From: amanda@adt.com.tw [mailto:amanda@adt.com.tw]
Sent: Thursday, April 20, 2006 6:16 AM
To: steve.cheng
Cc: eric@adt.com.tw; Ken_Lu@adt.com.tw; may@adt.com.tw; eden_ku@adt.com.tw;
hank@adt.com.tw; abby1688@hotmail.com
Subject: Revsied2: Re : TCB Review Comments for (B06-0420e- PY306100033- Netgear 11g router)

TCB Review Comments for (B06-0420e- PY306100033- Netgear 11g router)

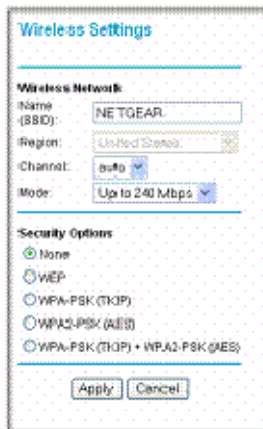
Question #1: All test plots are not readable, please increase the print resolution.

Question #1: All test plots are not readable, please increase the print resolution.
=>Report revised!
